Re: Paric Corporation Project No. 15051
15051-Webster University Interdisciplinary Science Building
CP-074 - ASI#39 - Electrical fixture revisions

Architect's Supplemental Instructions

Architect's ASI No: 039

Project:
Webster University
Interdisciplinary Science
Building

LEVEL 04 - AREA A - LIGHTING PLAN

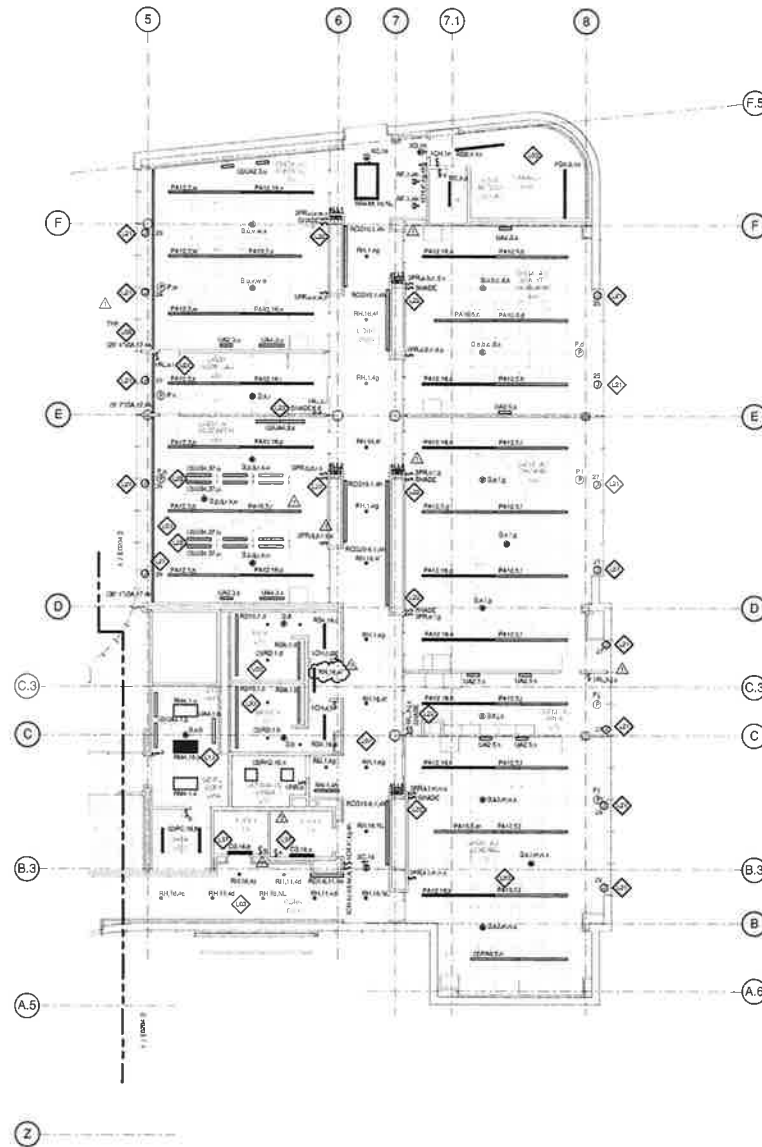
SHEET E0204.A LEVEL 04 AREA A FLOOR PLAN - LIGHTING

- In Corridor C480 revise Type RN fixture switching.

LEVEL 04 AREA B FLOOR PLAN - LIGHTING

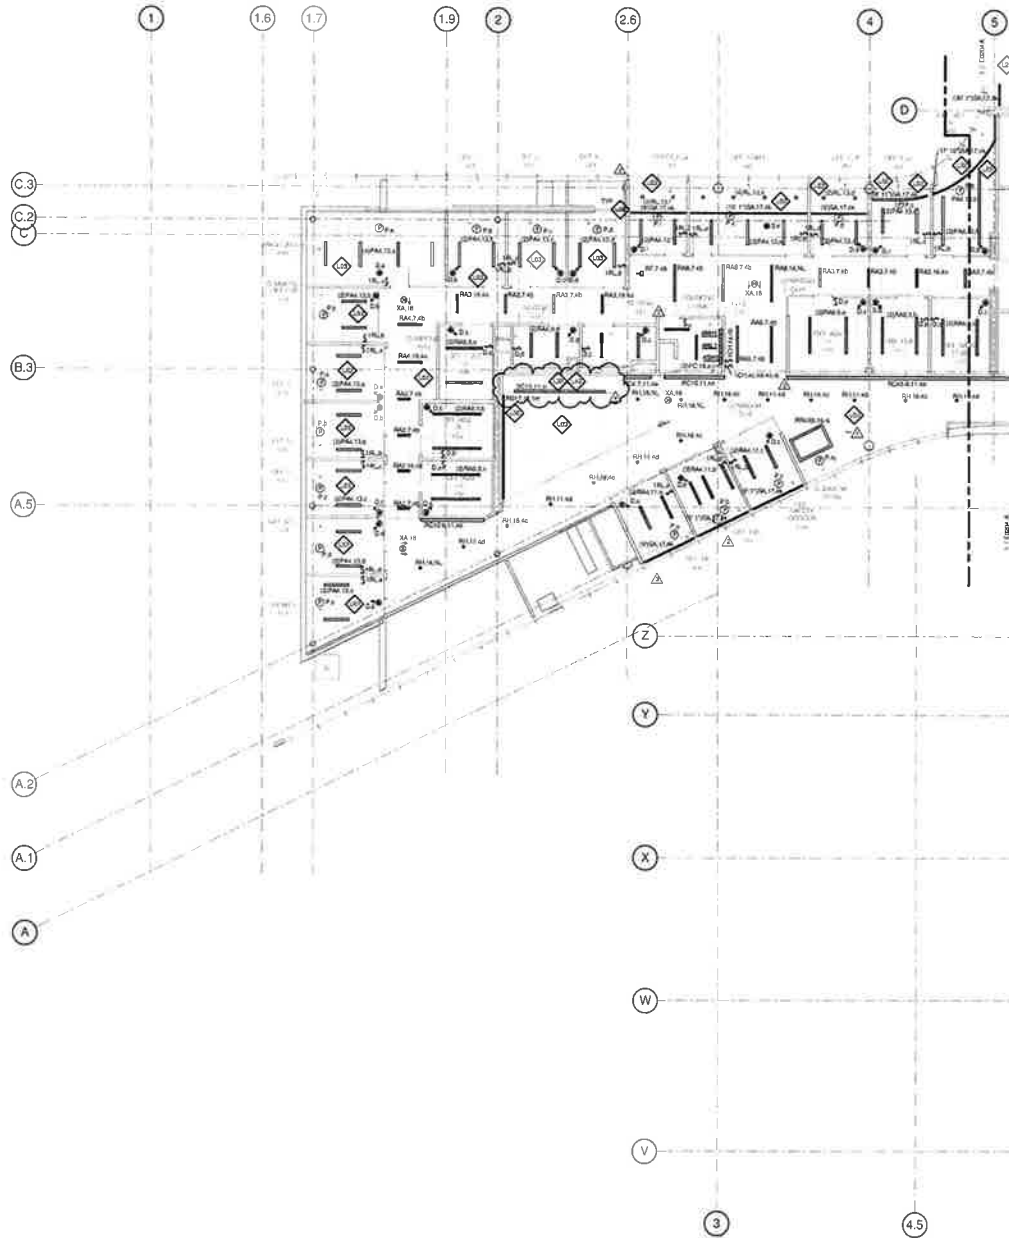
SHEET E0204.B LEVEL 04 AREA B FLOOR PLAN - LIGHTING

- In main stairwell, locate Type BC15 centered within skylight opening and 24" above bottom of stairwell ceiling.

- WHERE TYPE SA LIGHTS ARE LOCATED ON A CURVED WALL, PROVIDE FIXTURE SEGMENTS.
- LOCATE TYPE SC18 24" ABOVE BOTTOM OF STAIR CEILING, SHIMING DOWNWARDS.
